Customs Convention on the International Transport of Goods under Cover of TIR Carnets (TIR Convention, 1975):

Application of the Convention – Vehicles with sliding sheets

Vehicles and containers with sliding sheets

Submitted by the International Association of the Body and Trailer Building Industry

Sketch No. 10

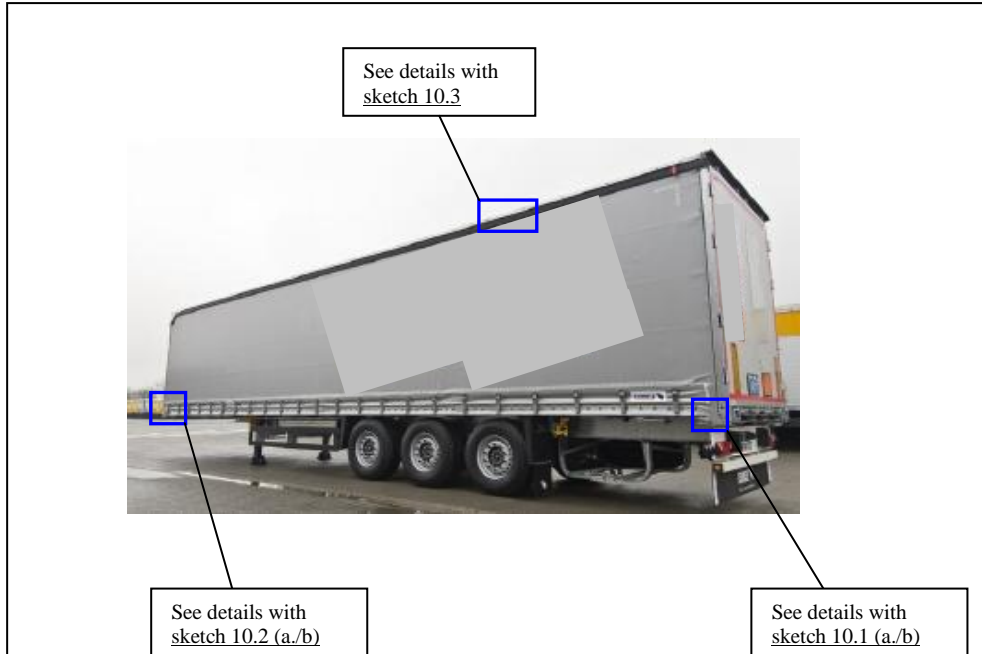
5. After Sketch No 9, add the following sketches:

This sketch shows an example of a vehicle and of important points described within Annex 2, Article 4, paragraph 3.

Sketch No. 10.1

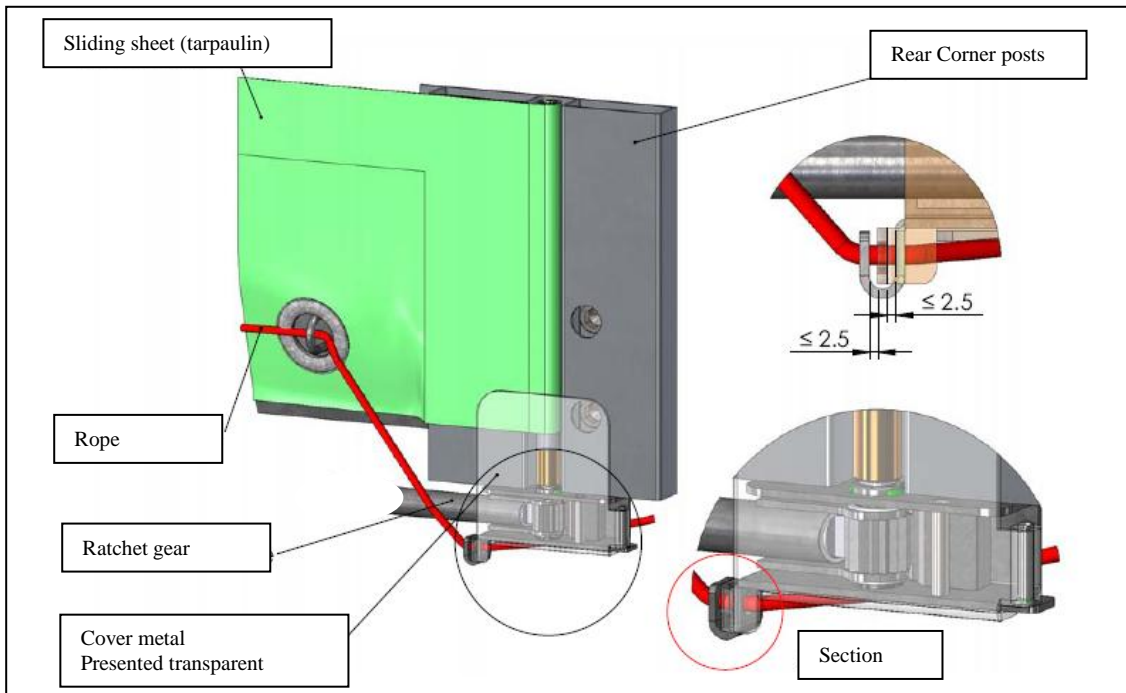
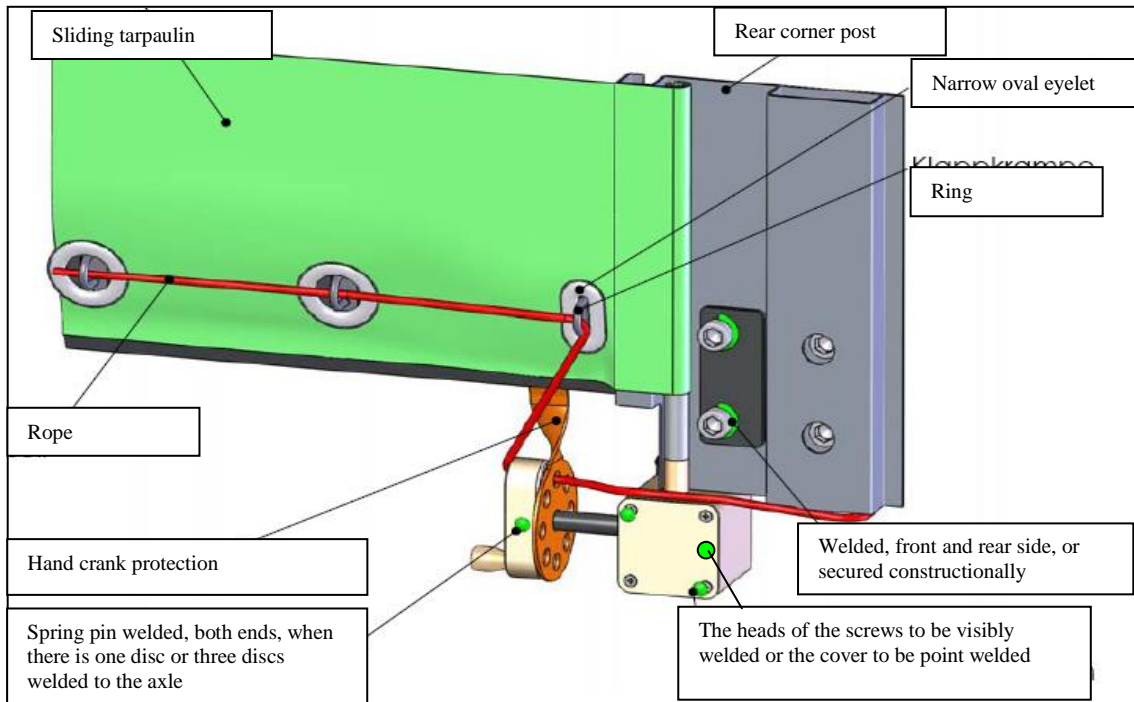
To tighten the tarpaulin in the horizontal direction, a ratchet gear is used (normally on the rear end of the vehicle). This sketch shows two examples (a) and (b) how the ratchet or gearbox may be secured.

(a) Ratchet securing

(b) Gearbox securing

Sketch No.10.2

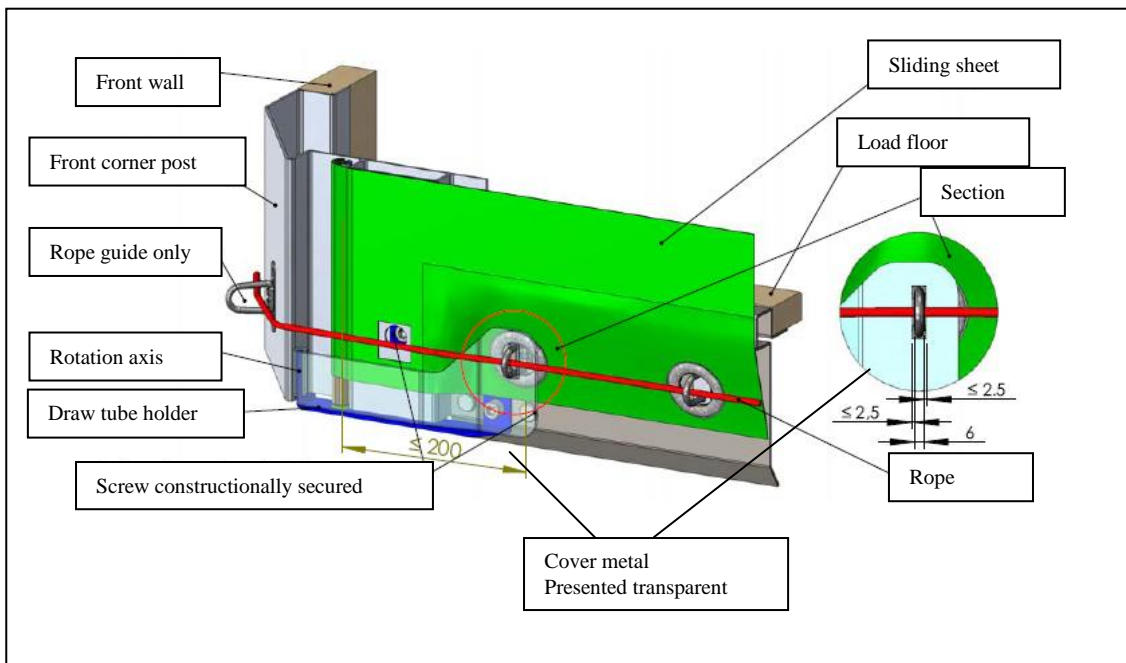
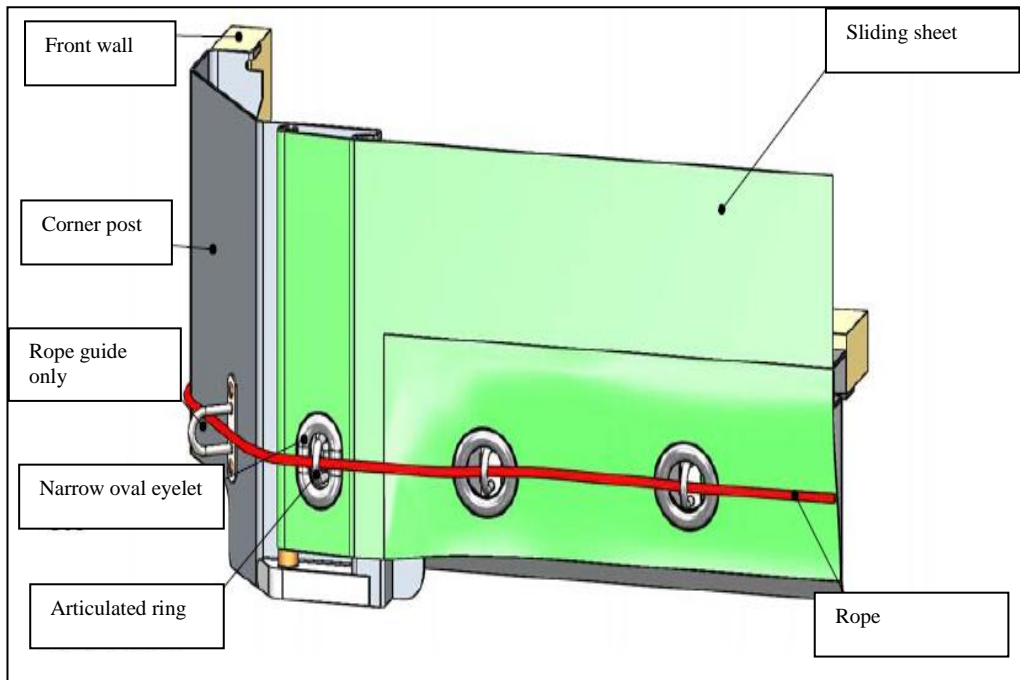
To fix the tarpaulin on the other side (normally to the front of the vehicles) the following systems (a) or (b) may be used.

(a) Cover metal

(b) Narrow oval eyelet, anti lifting system for the tensioning tube

Sketch 10.3

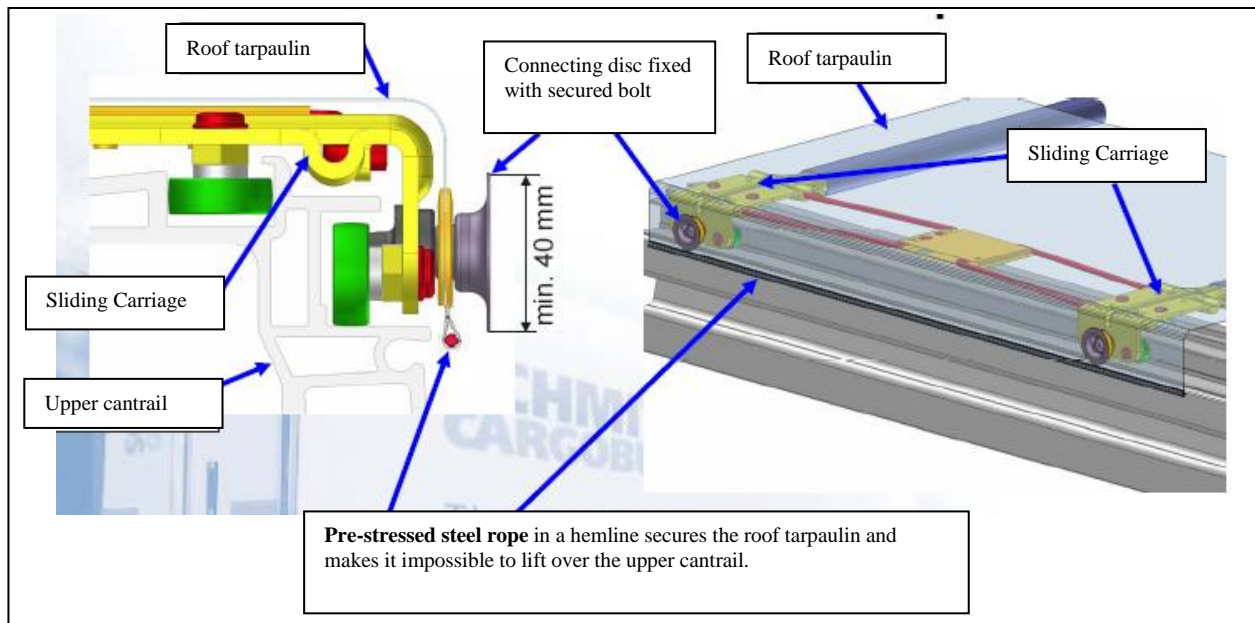
(iii) The sliding roof curtain shall overlap the solid part of the roof at the side of the vehicle, so that the roof curtain cannot be pulled over the top edge of the upper cantrail. In the hemline of the roof curtain a pre-stressed steel rope shall be inserted in such a way that it cannot be removed and re-inserted without leaving obvious traces. The roof curtain shall be secured to the sliding carriage in such a way that it can not be removed and re-secured without leaving obvious traces. The system is described in sketch No. 10.3 appended to these Regulations.

The custom security of the sliding roof is guaranteed if a pre-stressed steel rope, embedded in a hemline, is fixed. This steel rope is fixed to the front and rear of the vehicle. The tractive force as well as the connecting disc on each sliding carriage, makes it impossible to lift up the hemline with the steel rope above the upper cantrail.

Sketch No. 10

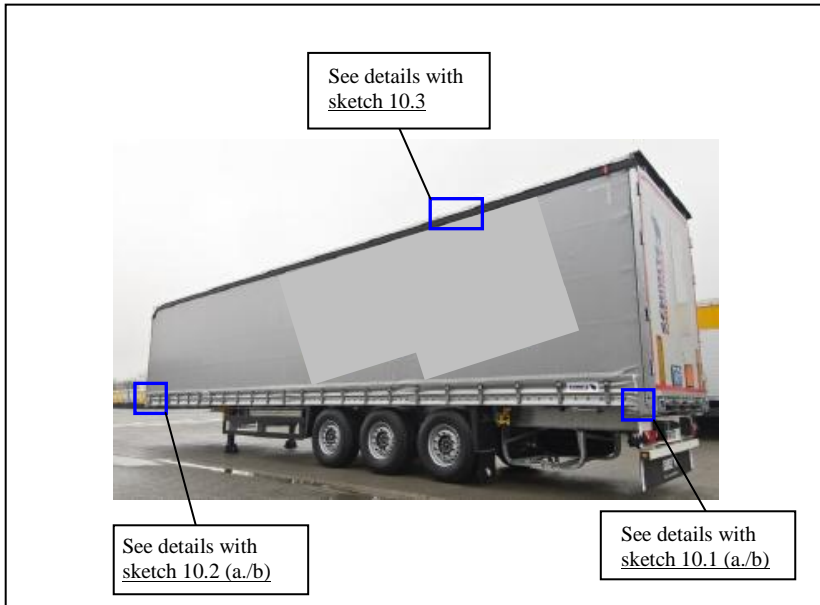
8. After Sketch No 9, add the following sketches:

This sketch shows an example of a container and of important points described within Annex 7 – Part I, Article 5, paragraph 3.

Sketch No. 10.1

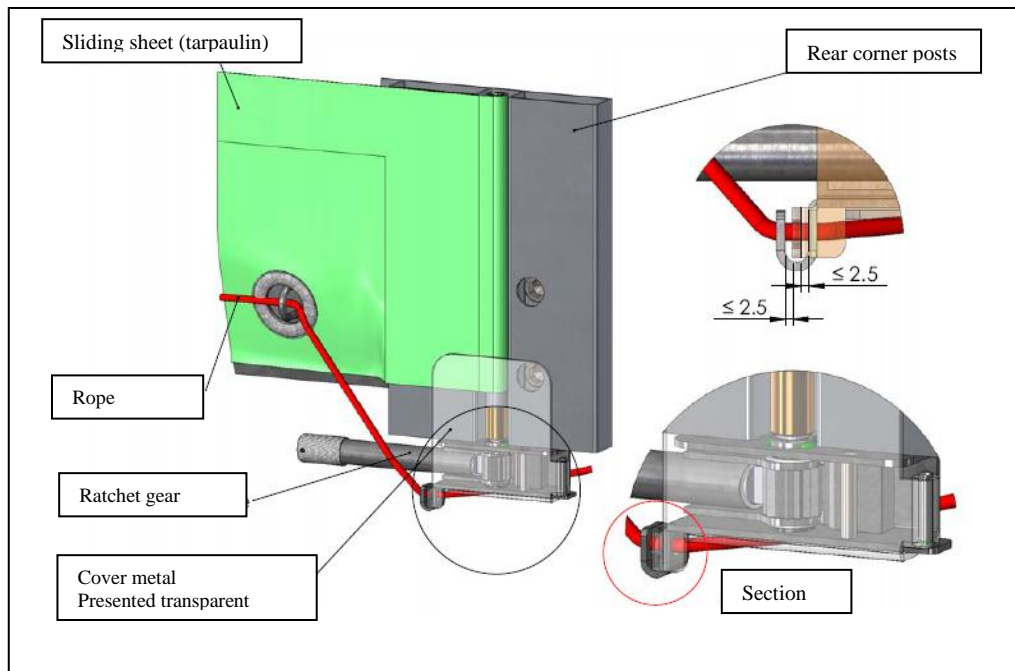
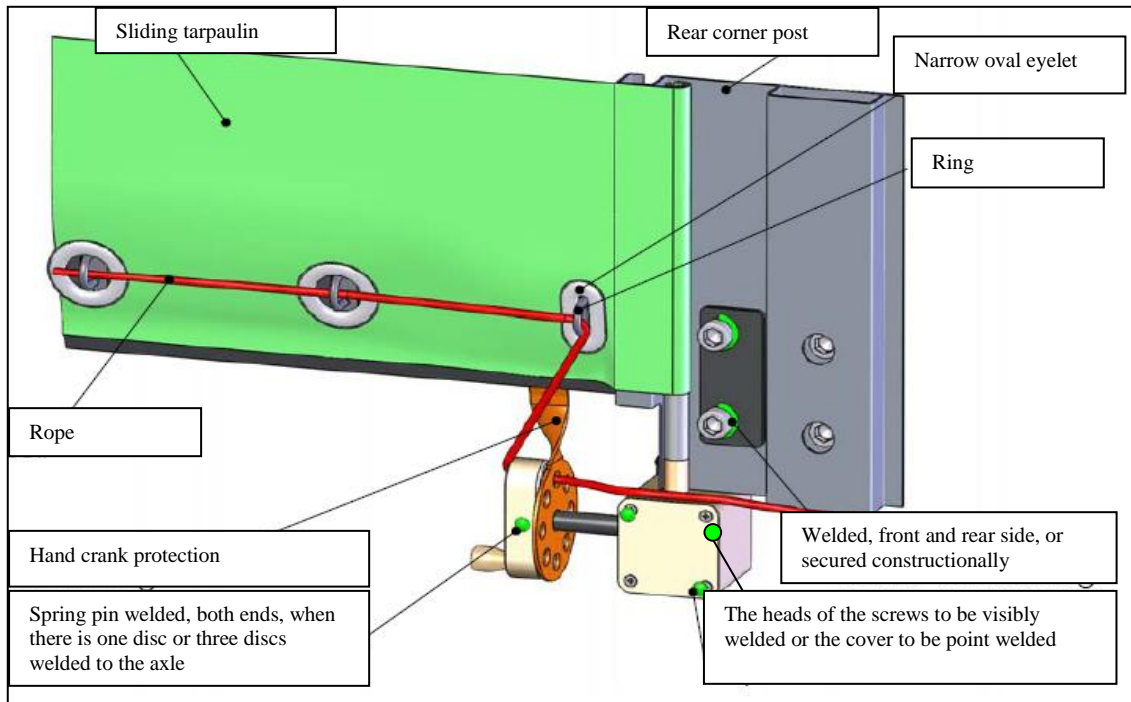
To tighten the tarpaulin in the horizontal direction, a ratchet gear is used (normally on the rear end of the container). This sketch shows two examples (a) and (b) how the ratchet or gearbox may be secured.

(a) Ratchet securing

(b) Gearbox securing

Sketch No.10.2

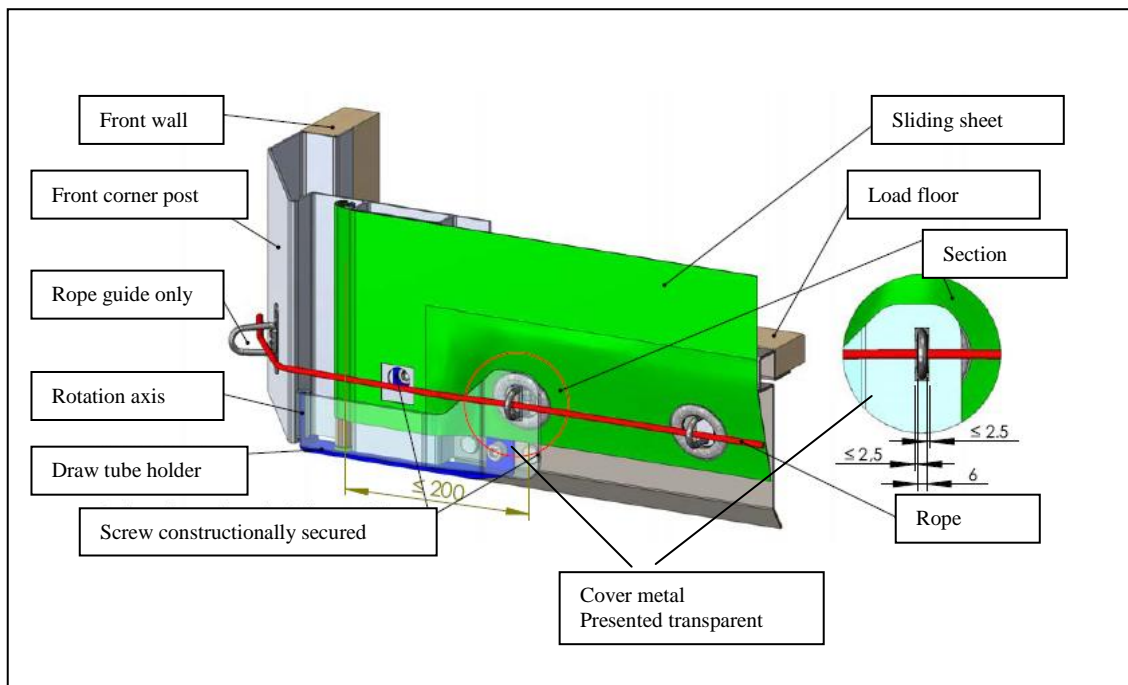
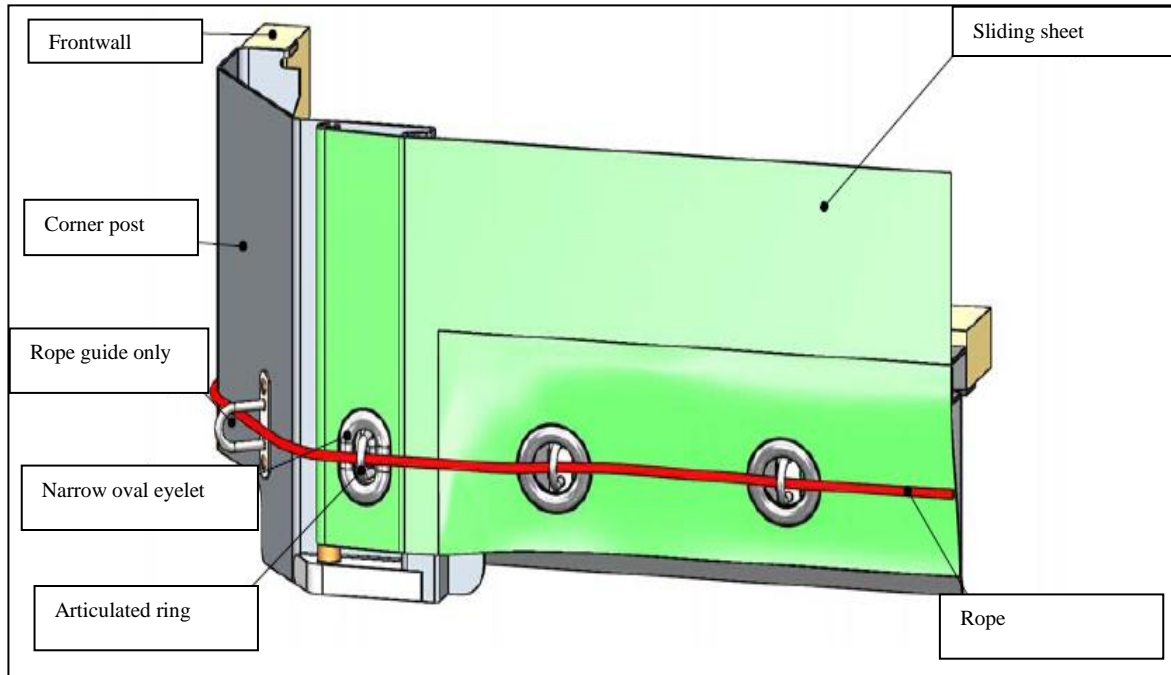
To fix the tarpaulin on the other side (normally to the front of the containers) the following systems (a. or b.) may be used.

(a) Cover metal

(b) Narrow oval eyelet, anti lifting system for the tensioning tube

Sketch 10.3

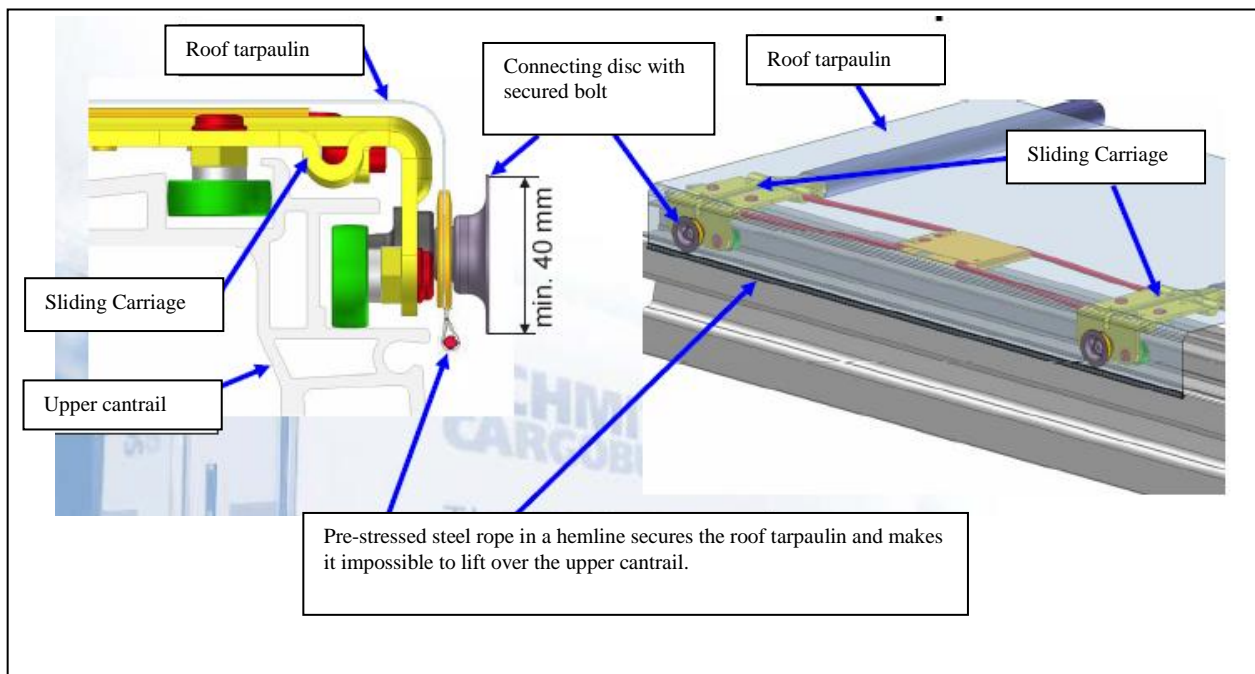
(iii) **The sliding roof curtain shall overlap the solid part of the roof at the side of the container, so that the roof curtain cannot be pulled over the top edge of the upper cantrail. In the hemline of the roof curtain a pre-stressed steel rope shall be inserted in such a way that it cannot be removed and re-inserted without leaving obvious traces. The roof curtain shall be secured to the sliding carriage in such a way that it can not be removed and re-secured without leaving obvious traces. The system is described in sketch No. 10.3 appended to these Regulations.**

The custom security of the sliding roof is guaranteed if a pre-stressed steel rope, embedded in a hemline, is fixed. This steel rope is fixed to the front and rear of the container. The tractive force as well as the connecting disc on each sliding carriage, makes it impossible to lift the hemline with the steel rope above the upper cantrail.
